1 Taviton Street

Listed Building Application to Amend Previous Consent:
2018/2970/L

March 2019

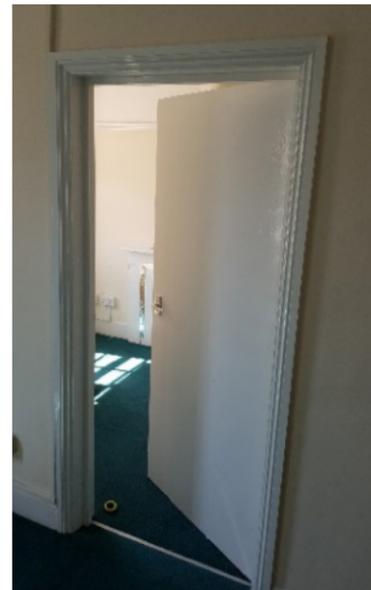
- Historic doors are to be retained and upgraded to meet the required fire rating requirements through an intumescent paint system. The final paint finish will be white, to match existing;
- Modern flush doors are to be replaced with new fire rated 4-panel doors, to match the original work;
- Un-original flat entrance doors are to be replaced with new fire rated 4-panel doors, to match original work.

Image 3 - Proposed Window Elevation

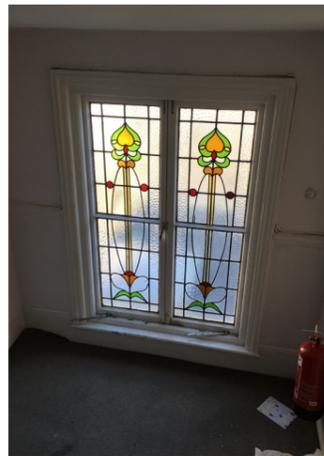
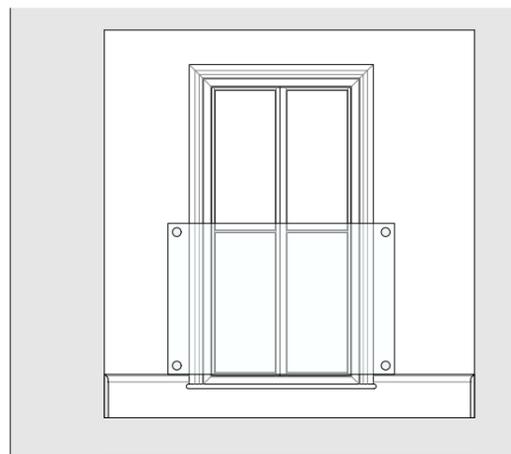
Between Second & Third floors, there is a window at low level on the half landing. The window is of leaded glass in an Art Nouveau style and is approximately 100mm above the internal finished floor level. The window is single glazed and its low level poses a risk to persons descending the stairs. Should someone trip, they could fall through the window and on to the flat roof, approximately 800mm below.

To provide protection, it is proposed that a single pane of structural glass be installed in front of the window, to a level of +1100mm. The glazing would be fixed directly into the brick wall and will be removable to allow continued maintenance access on to the flat roof.

Glass is proposed to ensure the window remains visible as it forms a significant part of the character and history of the property. The glass will not connect with the window, sill or frame in any way.

Image 2 - Proposed Fourth Floor Plan

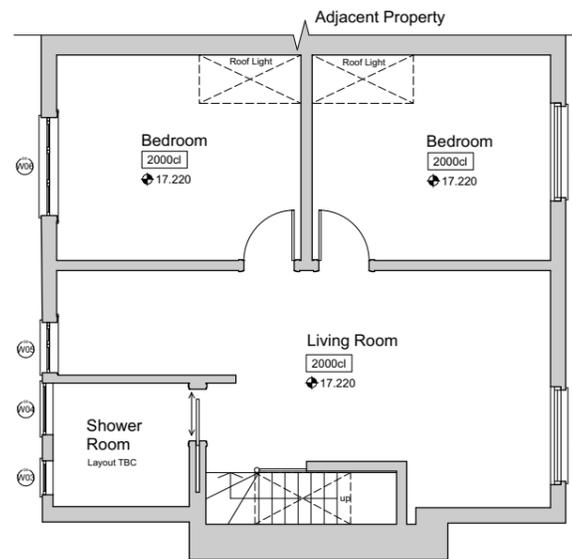
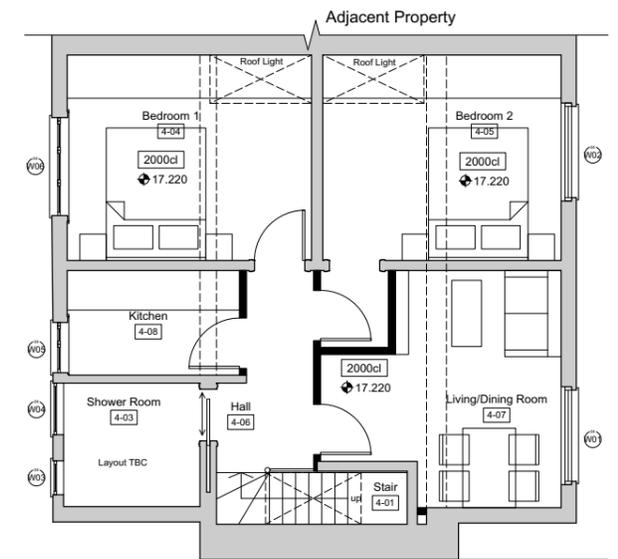
The consented fourth floor layout (consented separately to the rest of the property under reference 2016/0263/L) provides for an open plan Kitchen, Living and Dining Room. As the bedrooms are accessed from the open plan space, there is an issue with the bedrooms being 'rooms within rooms'. The team reviewed various options to mitigate this risk, including installing a misting system however, the harm this would cause to the historic fabric in addition to the extra cost, meant this option was not viable.

The simpler solution was to provide a protected lobby between the stair and bedrooms to provide a safe means of escape. The addition of this lobby splits the Kitchen from the Living/Dining Room.

The below two images show the consented layout (image 1) and the proposed layout (image 2). The black partitions shown in image 2 are the new, proposed partitions of the protected lobby. Further details are provided in section 3.

Image 2 - Proposed Ground Floor Plan - Elec. Cupboard

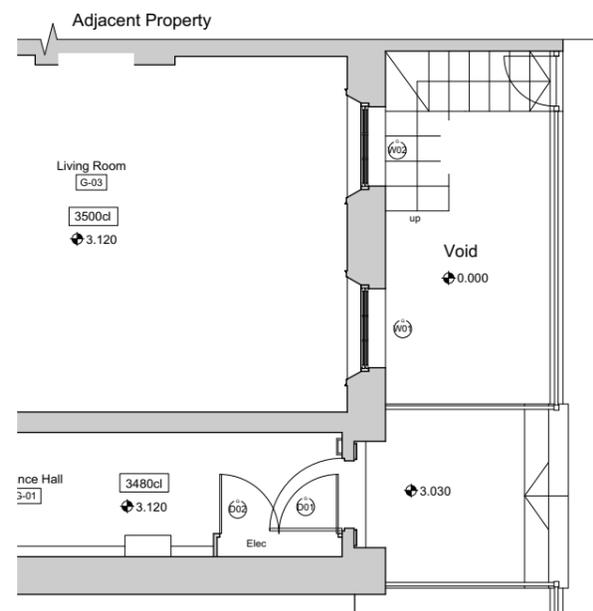
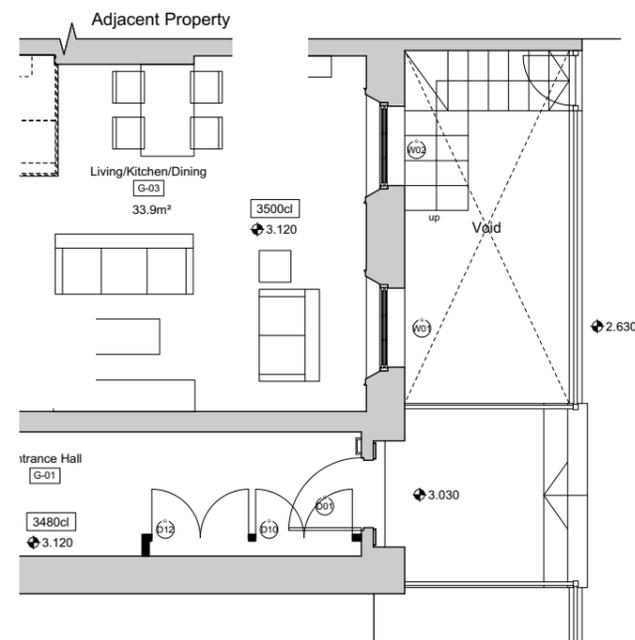
An electrical cupboard currently exists at Ground Floor and is located in the main entrance hall, by the front door. Permission has been granted (under consent 2018/2970/L) to demolish the existing electrical cupboard to provide a new, fire rated cupboard to house the upgraded electrics for the property.

The M&E consultant has now set out their electrical requirements and the new cupboard has increased in size from 1.8m wide, to 3m wide. The cupboard will be rebuilt to the same height as the existing, i.e. without disturbing the historic features.

The enlarged cupboard is required to accommodate the new meters for each apartment. The utilities company have strict criteria with regard the setting out of the meters and we have therefore had to widen the cupboard to comply with these requirements.

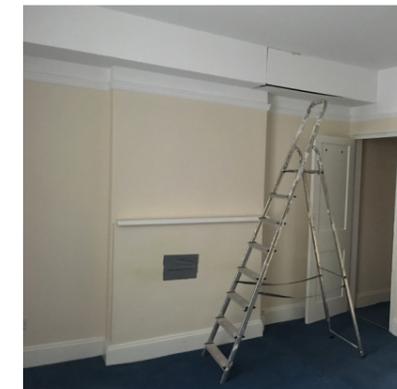
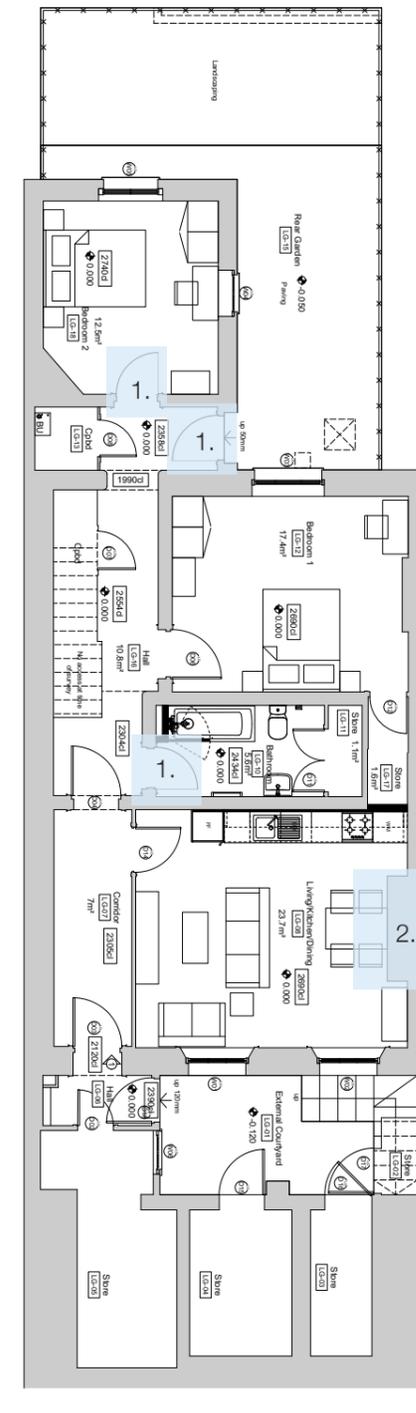
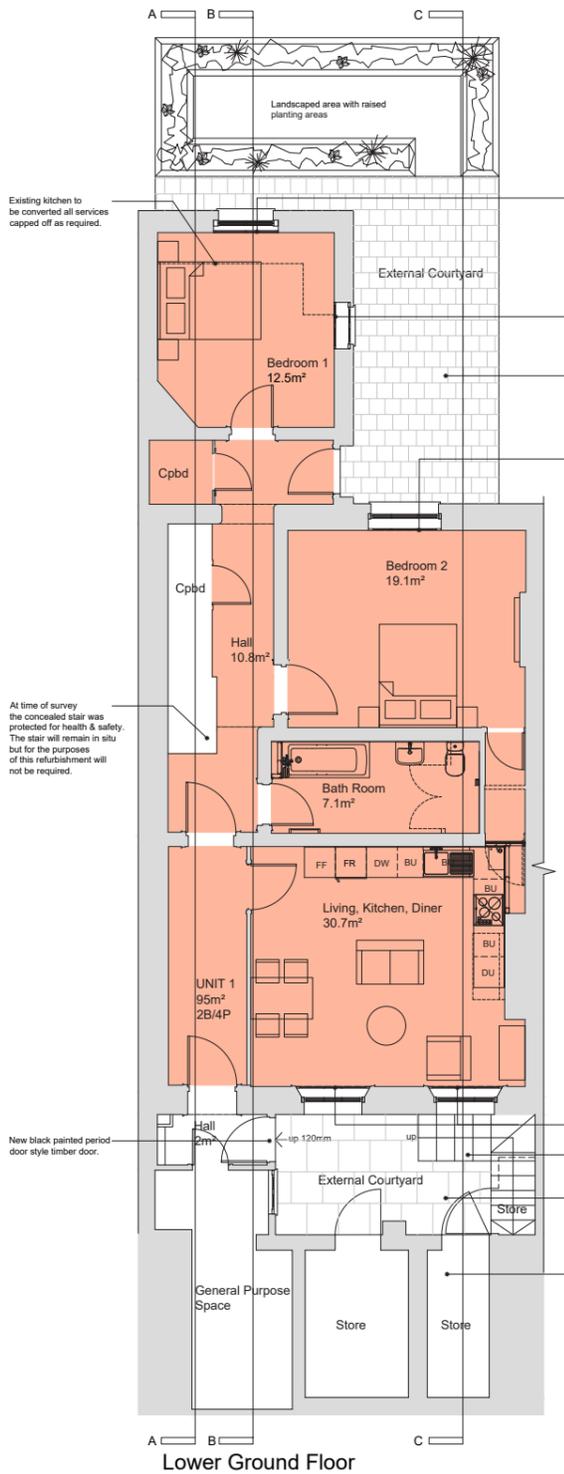
The exception to this is at First Floor, where there are two fine examples of marble surrounds. We have been unable to confirm whether they are original to the property however, they are well suited to the space and of historic value. The fire places at First Floor will therefore be retained, see Photo 1 below.

All other surrounds are of poor quality, low significance and do not add to the character of the property. We therefore propose to remove the remaining modern surrounds to improve the efficiency of the plan. The fireplaces will be infilled with fire rated material, to match others throughout the house (See photo 2 below).

GROUND FLOOR- PROPOSED SCHEME

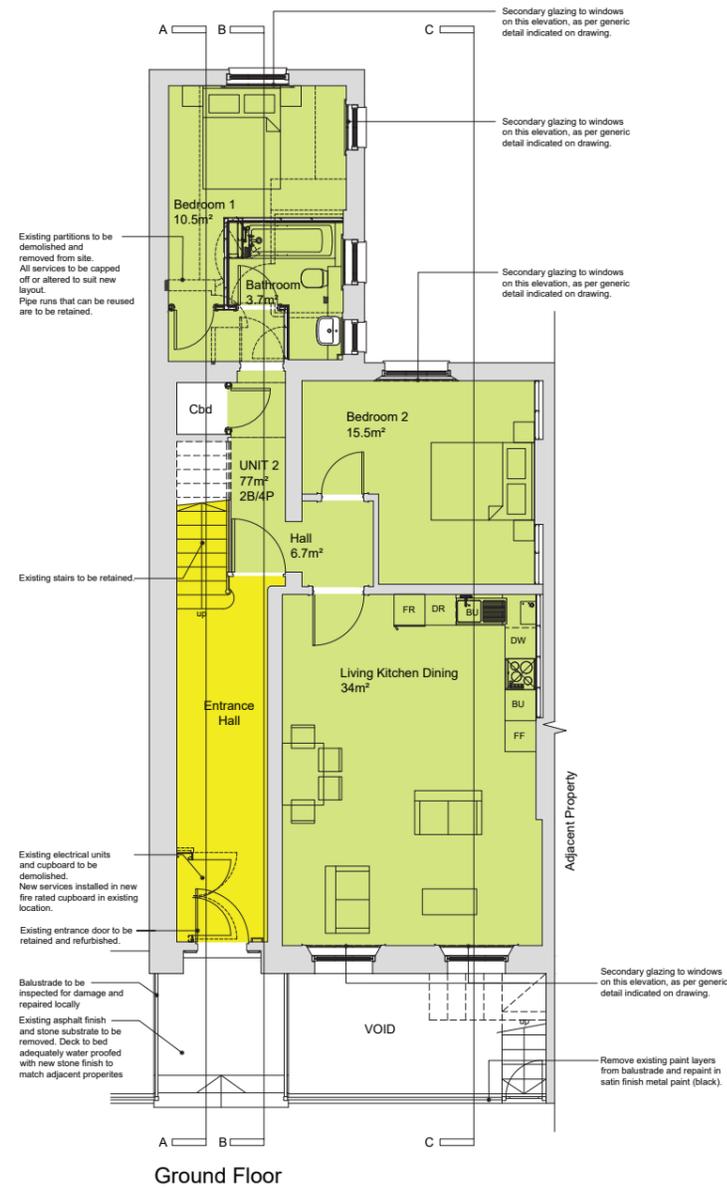
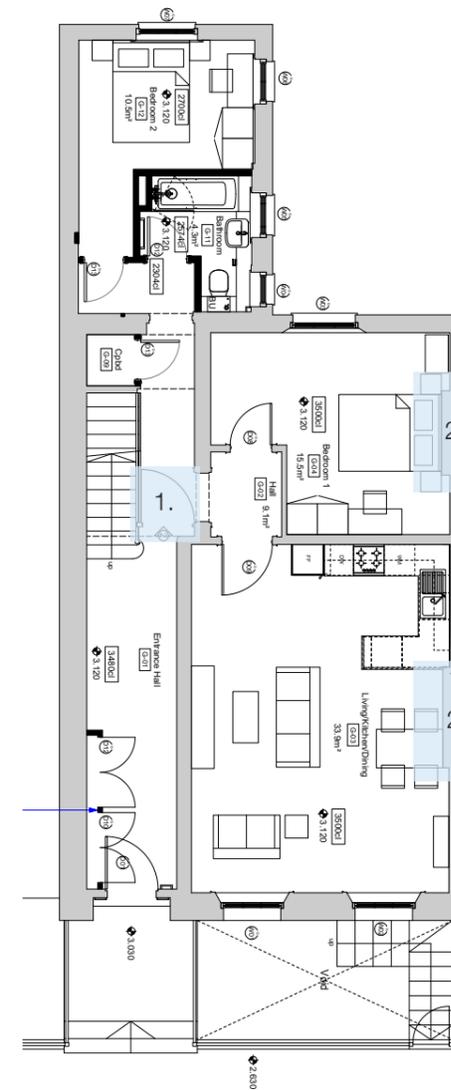
1. Door G-D03 to be removed & replaced.
2. Modern fire surround to be removed.

FIRST FLOOR- PROPOSED SCHEME

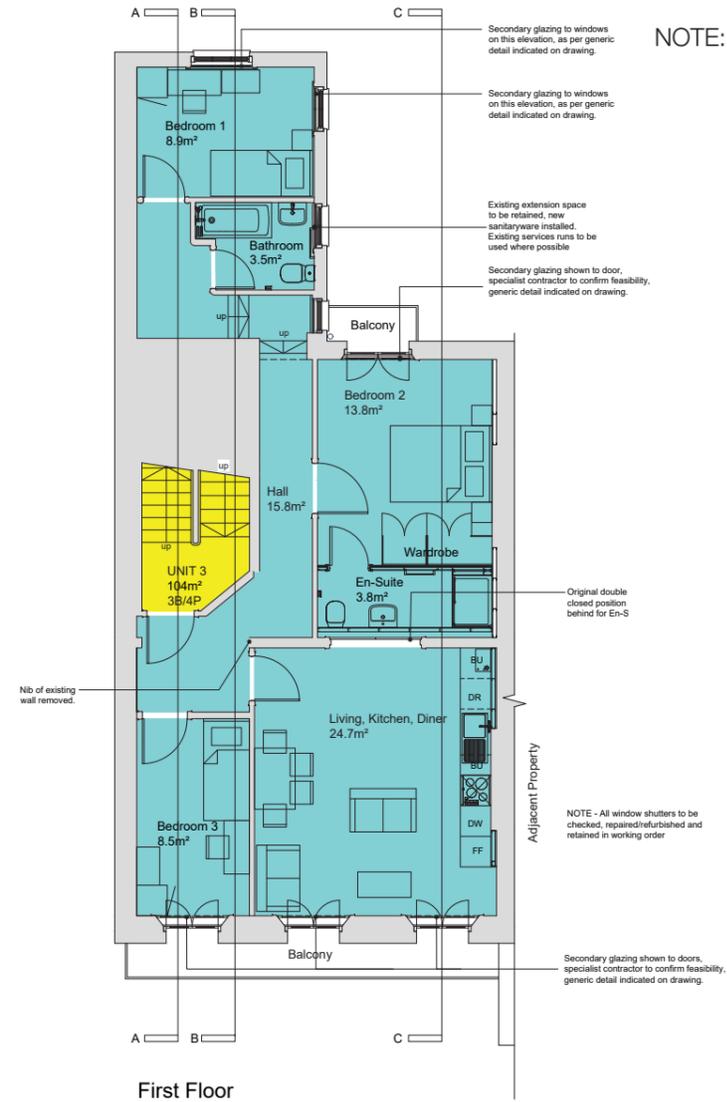
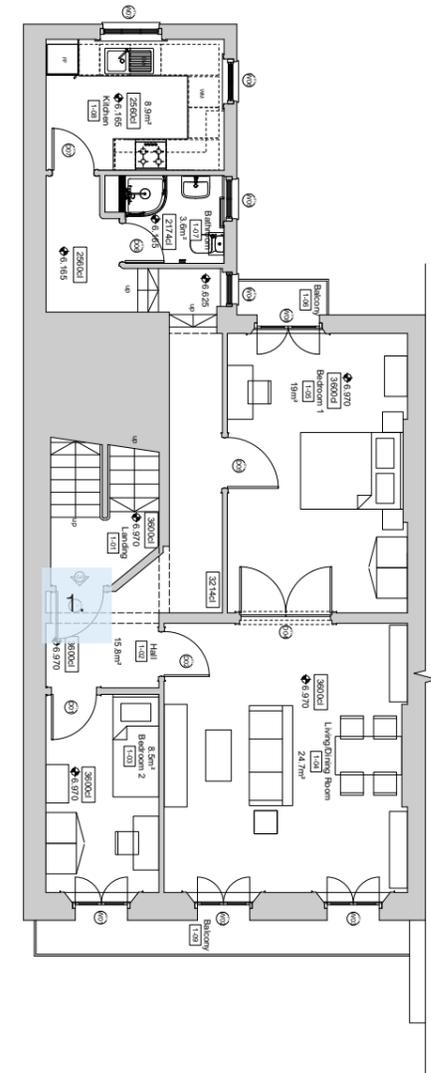
1. Door 01-D03 to be removed & replaced.

MEZZANINE FLOOR- PROPOSED SCHEME
NOTE: Permission was granted to ammend the layout of the Micro Flat previously, under reference 2019/0482/L.

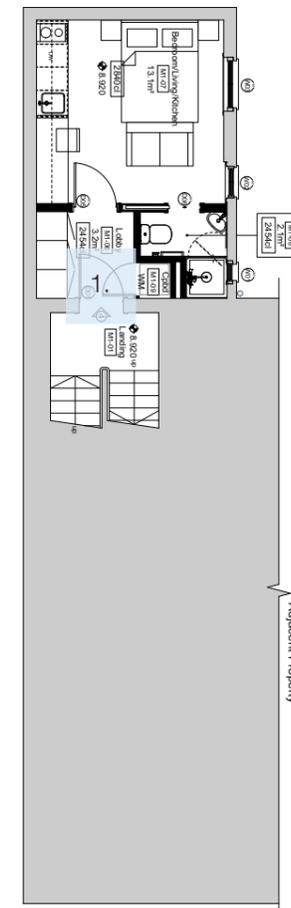
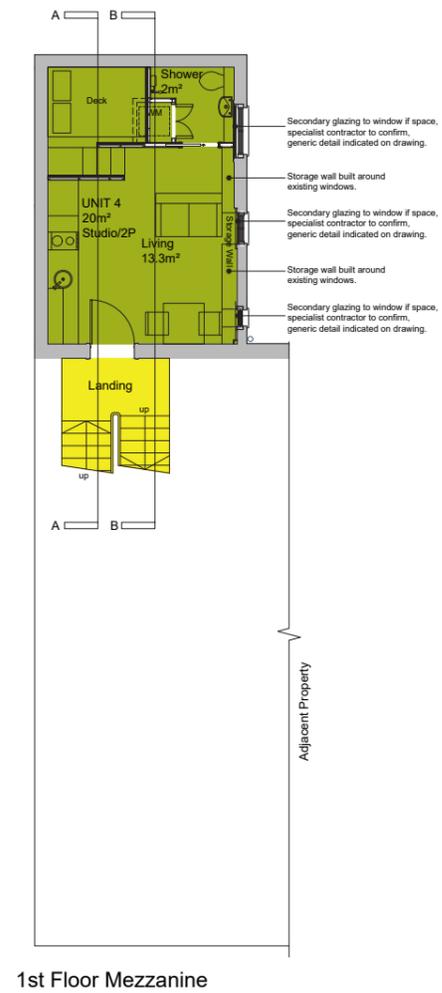
1. Door M1-D01 to be removed & replaced.

SECOND FLOOR- PROPOSED SCHEME.

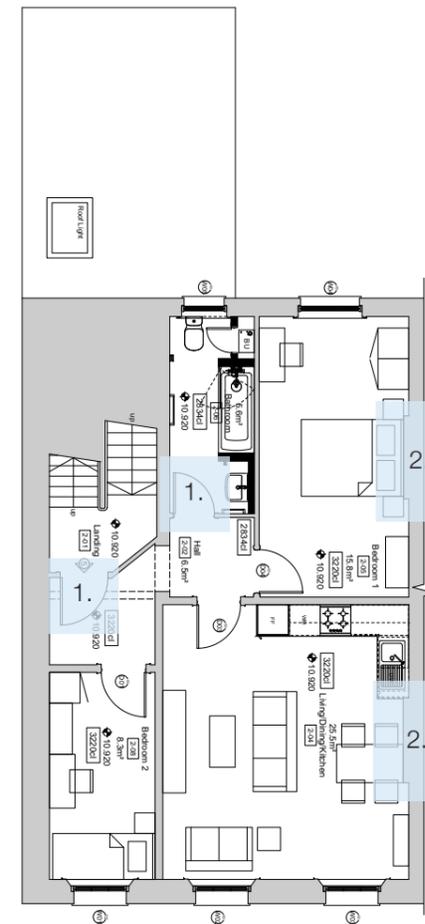
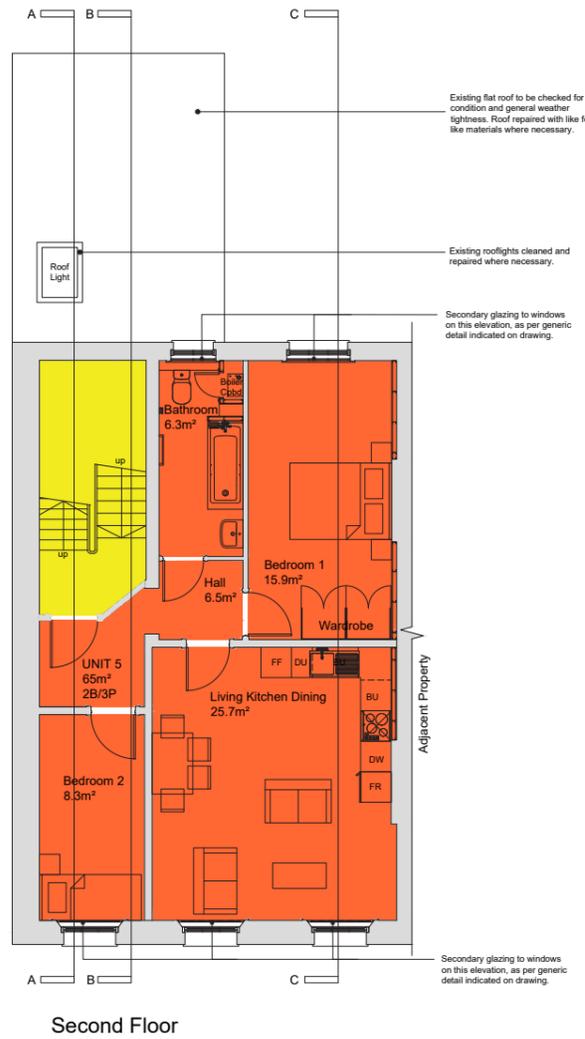
- 1. Door 02-D02 & D05 to be removed & replaced.
- 2. Modern fire surround to be removed.

THIRD FLOOR- PROPOSED SCHEME.

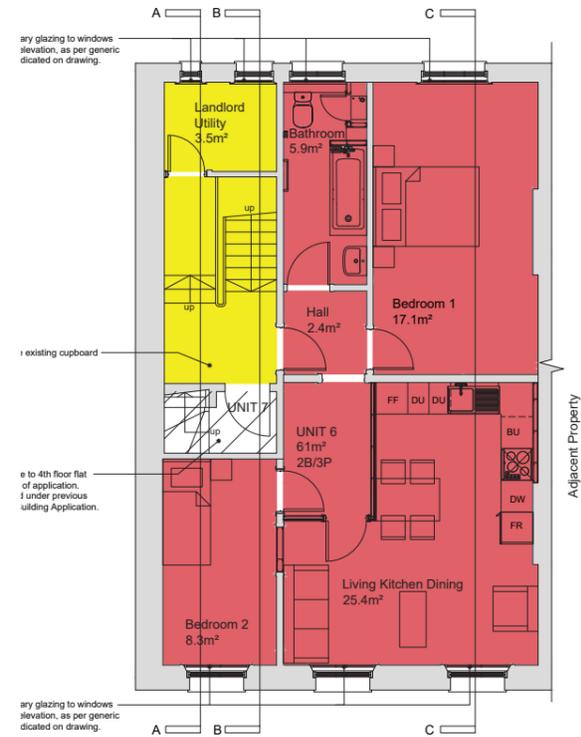
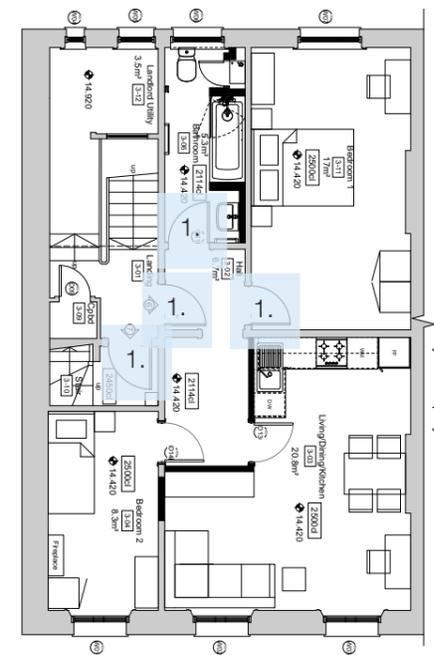
1. Doors 03-D02, D05, D06 & D07 to be removed & replaced.

FOURTH FLOOR- PROPOSED SCHEME.

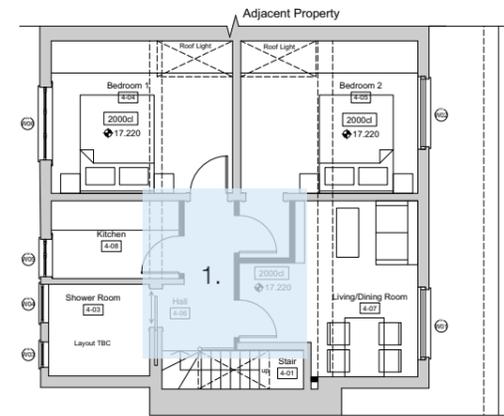
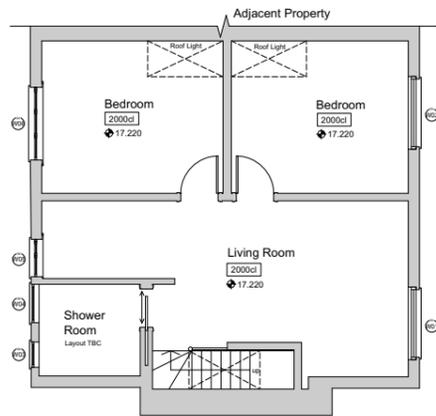
1. Protected Lobby added.
